Top Housing Base Screw Torque Correction

Models Affected

Tour ES, Excel, Digital Steering, PTSv

18574

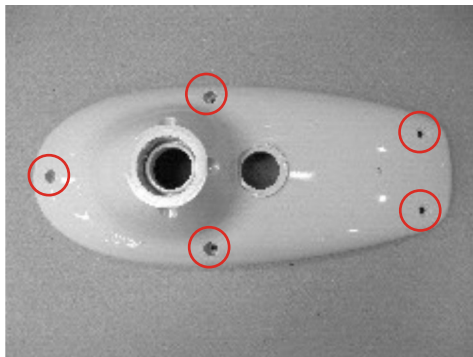
Screws attaching the top housing cover to the top housing base have incorrect torque specifications in service manuals 90-MXC5900 and 90-MXC5901. The incorrect torque values can cause the top housing to be loose or to break.

The screws in the five illustrated locations must be tightened to 17 - 19 lb. in.

The top housing screws should be tightened to specifications.

Description	Nm	lb. in.	lb. ft.
Top housing screws (M00603)	1.92 - 2.15	17 - 19
